Mat'l. For: DBS Formsavers

SUBMITTAL IDENTIFICATION SHEET

PROJECT: 15051-Webster University Interdisciplinary Science Building

RE: DBS shops for slab reinforcement per addendum 1-8

(14) FRAMING SECTION
3/4" = 1'-0"

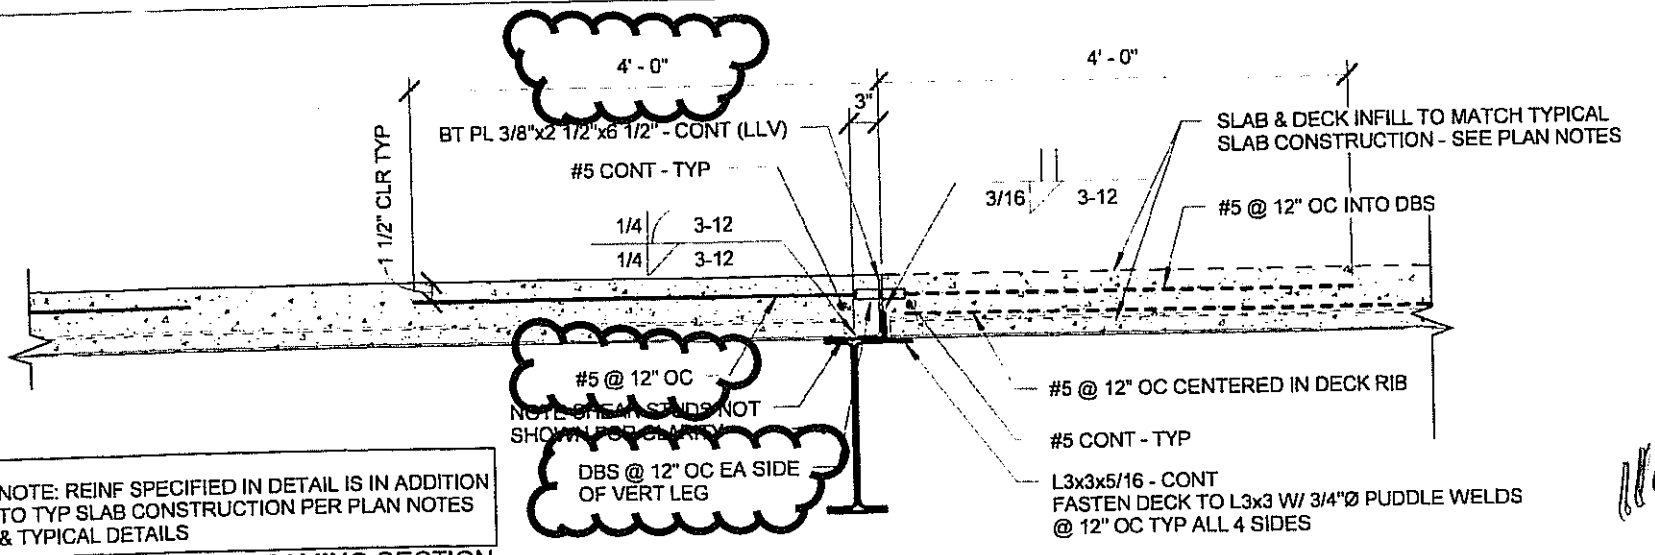
CLARIFY INTENT OF CONSTRUCTION:

ORIGINAL DETAIL INDICATES FEMALE COUPLERS ON BOTH SIDES OF ANGLE AND THEN COUPLERS ARE WELDED TO VERTICAL LEG OF ANGLE. (WOULD REQUIRE 100 FEMALE BARS, EACH 4' LONG)

OPTION FOR ABOVE MATERIAL REQUIRES DRILLED HOLES IN THE BENT PLATE AT THE BAR LOCATIONS. EITHER - MALE END SET AND EXTENDED THRU BENT PLATE SUFFICIENT FOR FEMALE BAR TO ATTACH BEFORE SLAB INFILL POUR - OR - FEMALE END SLEEVED THRU HOLES WITH COUPLER EXPOSED ON SLAB INFILL SIDE. DRILLED HOLES WOULD BE SET 1/2" LOWER ON THE EAST & WEST SIDES. THESE ARE ACCEPTABLE ALTERNATES AT NO COST TO THE OWNER. (WOULD REQUIRE 50 FEMALE - 50 MALE, EACH 4' LONG)

PERIMETER OF OPENING IS APPROXIMATELY 50' - VERIFY QUANTITY

110 EA. DBS's
